BLOOMINGTON HISTORIC PRESERVATION COMMISSION
Showers City Hall
McCloskey Room
Thursday April 10, 2014
5:00 P.M.
AGENDA

COA-06-14

COA-08-14 **1206 East Wylie**
Owner: Birk Billingsley

COA-07-14 **823 West 4th Street**
Owner Bloomington Restorations, Inc.

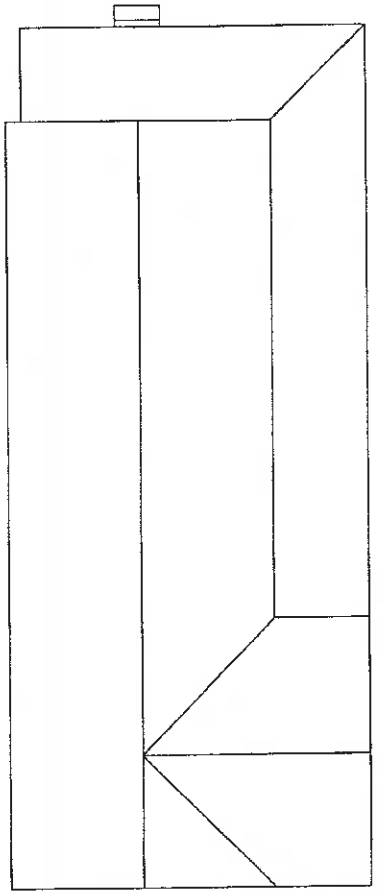
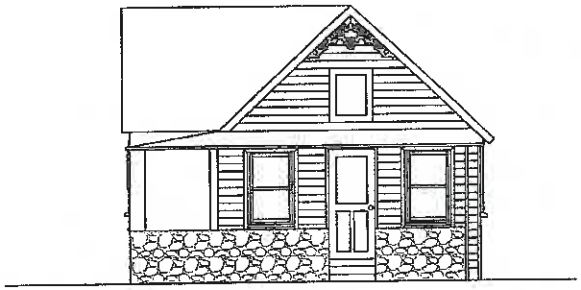
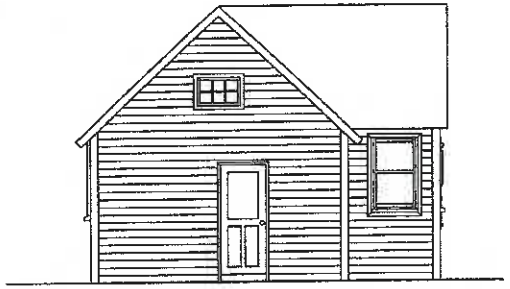
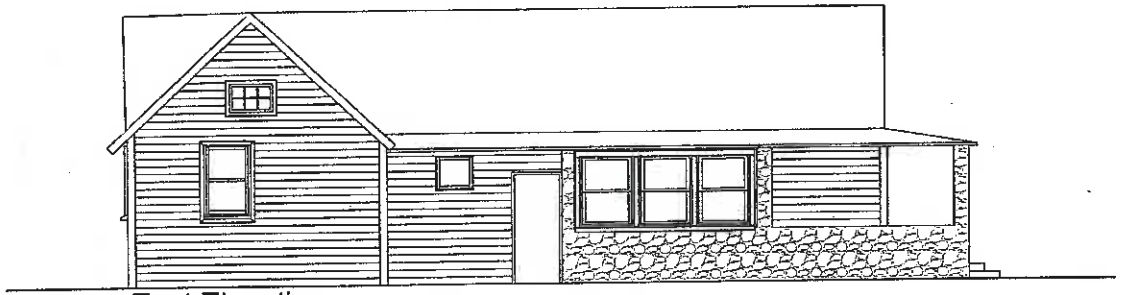
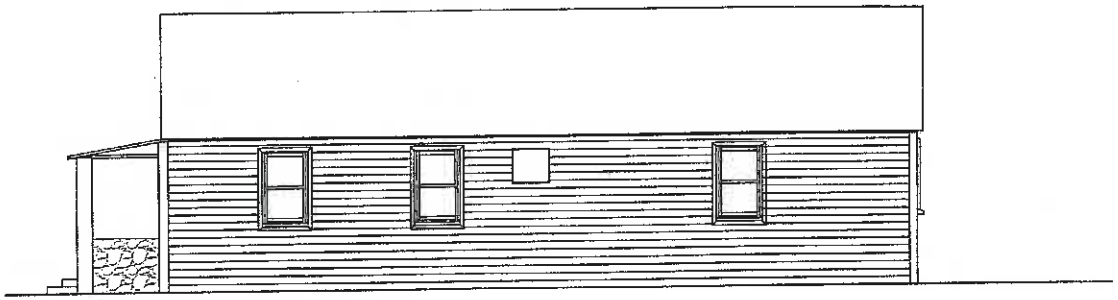
In addition to completing an exterior restoration, the owner wants to remodel interior space in a non-historic addition to the rear of the house. For this to be feasible, the principal gable will be extended all the way to the rear facade and an intersecting gable to the east constructed. All of this will occur over the current foundation so it is not a true expansion of space. The resulting house will increase from two bedrooms to three, but will stay about 1000 square feet of living space, making it fall well within the guidelines for average house size in the Prospect Hill District.

The rear part of the building is visible from a North -South Alley, but not from the main thoroughfare. There has been agreement on a relative lack of concern for rear modifications during these new discussions as well as within the full Historic District that was listed in 1991. Plans include matching the dimension of the exterior framing on the original house with cement board at the rear, and replacing only non original windows. These windows will be resized to be more compatible with era of the building.

The cementitious siding will only be used on the new walls of the rear addition and will be cut to match the existing wood siding on the rest of the house.

The work to the rear of the house will be on a later addition to the existing structure, that (see pictures# 1,4,5,7) has much later fenestration and is not a significant feature. The reworking of the roof system will be a practical improvement in the building, allowing for better use of the existing interior space. Plans propose chimney removal, the structure for which is probably an original feature of the house. It was functionally a brick flue to a stove that has, long ago, been removed from the structure. Interior plans call for a bathroom in this location. Staff does not view the chimney removal as loss of a character defining element.

Staff recommends approval.

823 South Fess
Scattered Sites
Owner Lucy and Robert Fischman

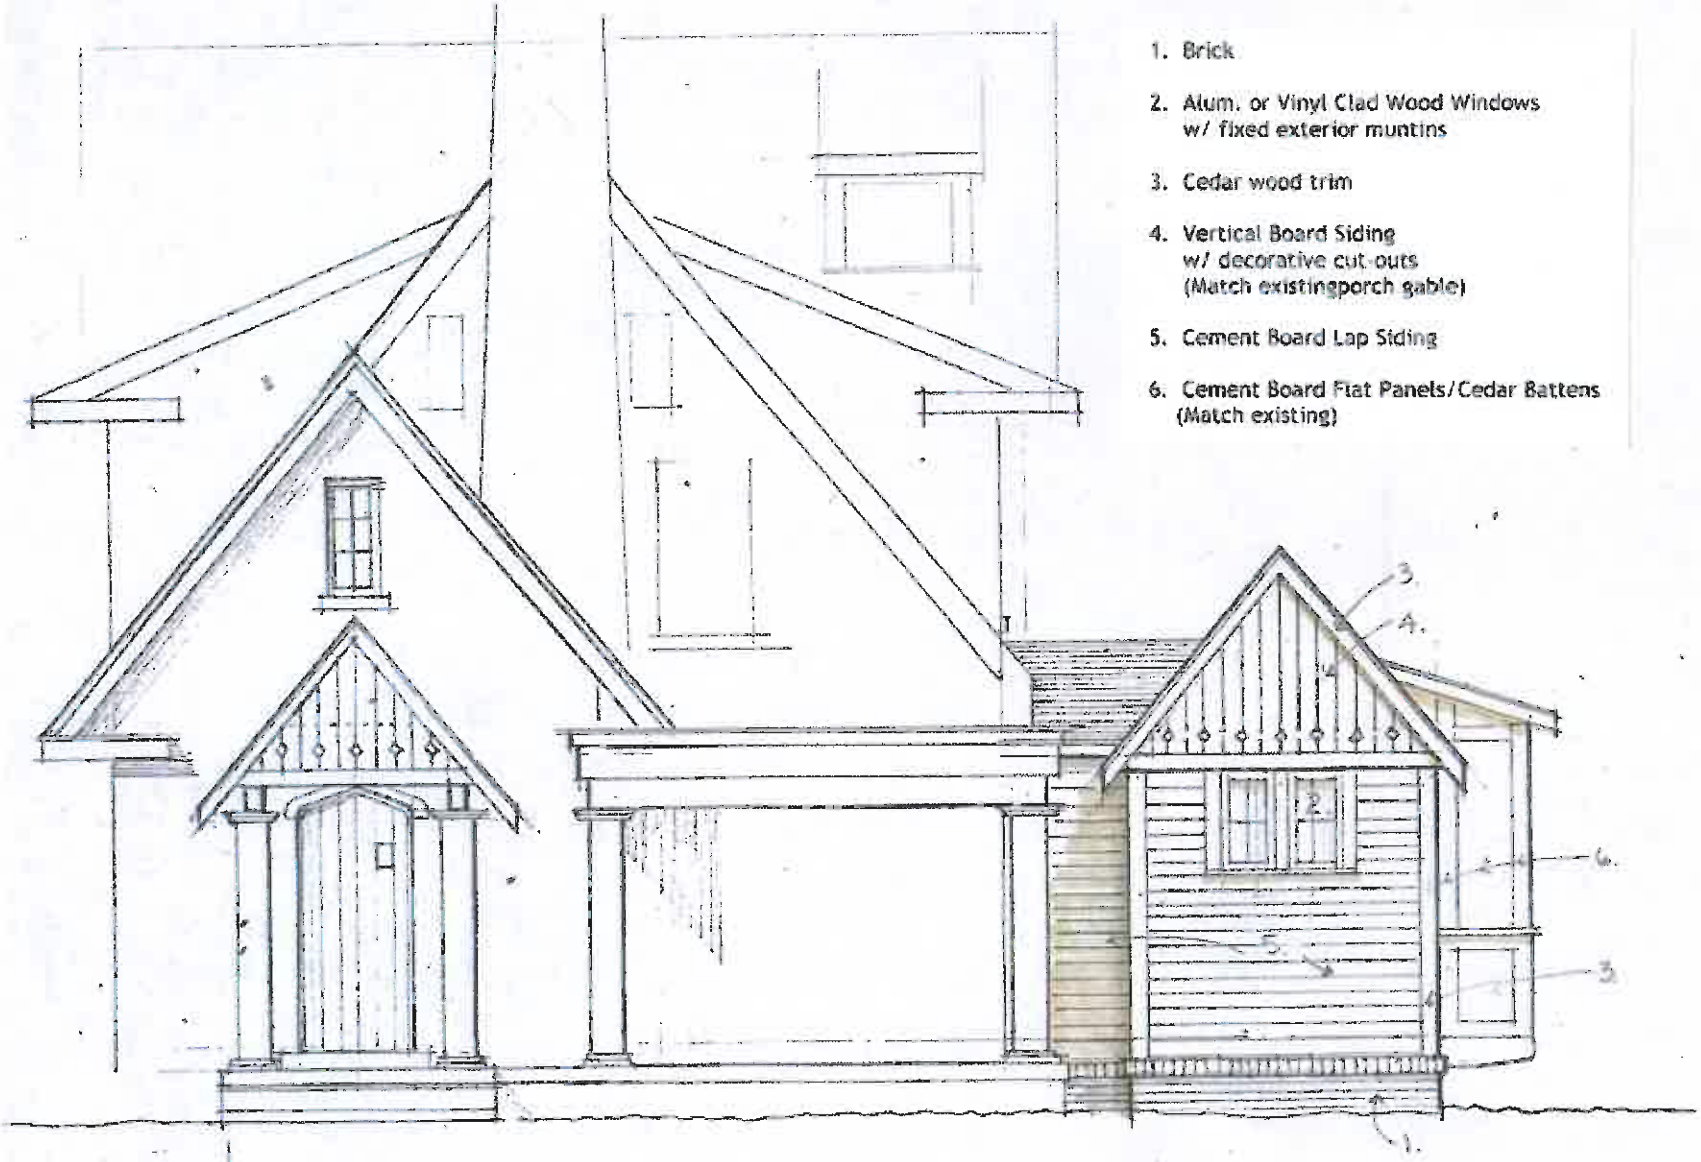
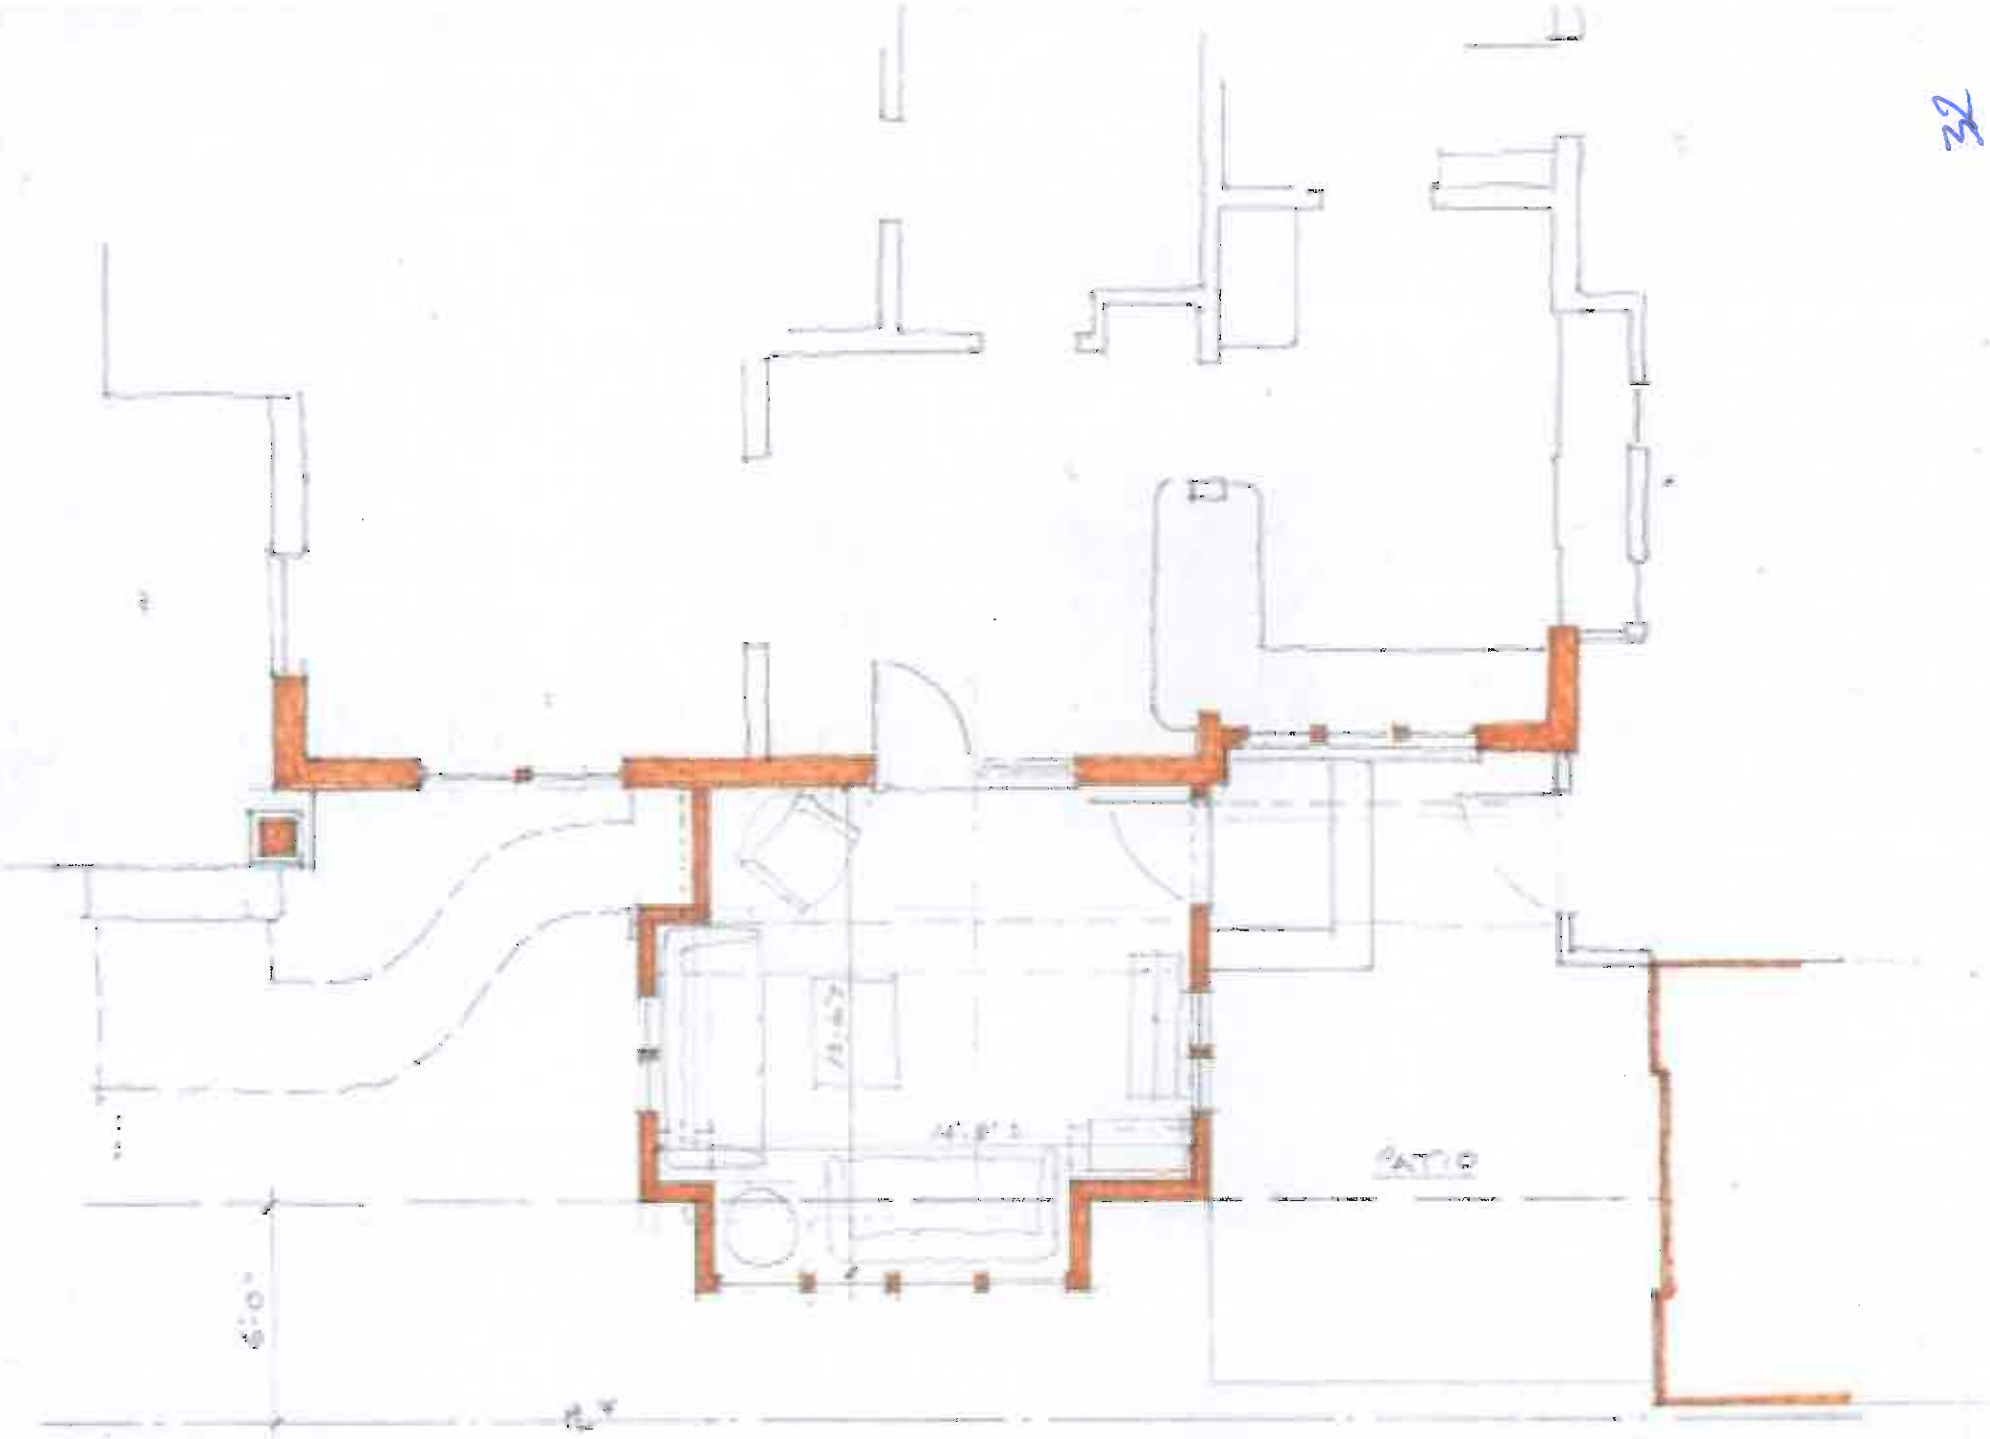
PROPOSAL:
The owners will create a small addition on the south side of the house with a cantilevered bay window. The roof system will be cross gabled in order to draw the floor space out without covering the existing second floor windows on the main house. No original material will be removed for this addition. The existing french doors and frame will be retained and the brick wall will remain on the inside. The vertical framing beneath the gable on the west (Fess) side of the house will match the gabled entry. The bay will contain a multi-light ribbon window covered by a small shed roof. Cross-timbering on the bay reflects the design of the 2004 addition that is most visible on the south side of the house towards the driveway..

The addition is approximately 13.5' by 14.8' and contains 203 square feet.
